# Access Compliance Report Public Rights-of-Way (Curb Ramps)

Main Street: SIENNA\_PKWY Cross Street: WALDEN\_ST Location: SW

ADA ID: RPRK211020173614 Ramp Type: Type 1 - Perpendicular Diagonal Initial Pass/Fail: Fail Overall Compliance: No Severity Score: 16

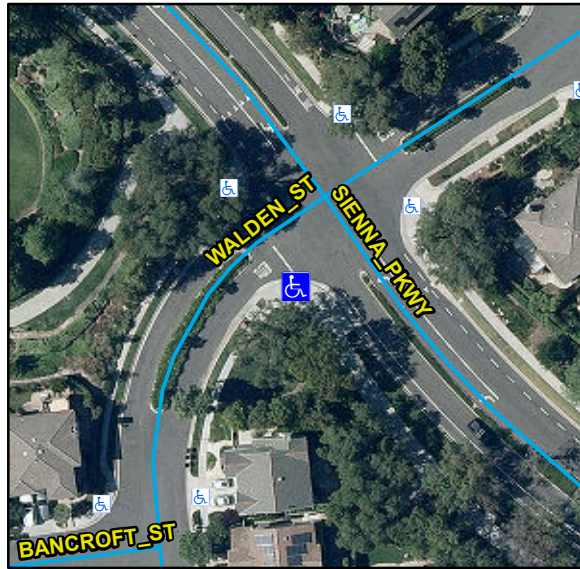
| Compliance | Description                           | Data | Compliance | Description                   | Data |
|------------|---------------------------------------|------|------------|-------------------------------|------|
| No         | Ramp Run Slope (%)                    | 8.8  | N/A        | Flare Slope LT (%)            | N/A  |
| No         | Ramp Cross Slope (%)                  | 4    | N/A        | Flare Traversable LT          | N/A  |

Remove & Replace Curb Ramp With Two New Directional Ramps or Equivalent.
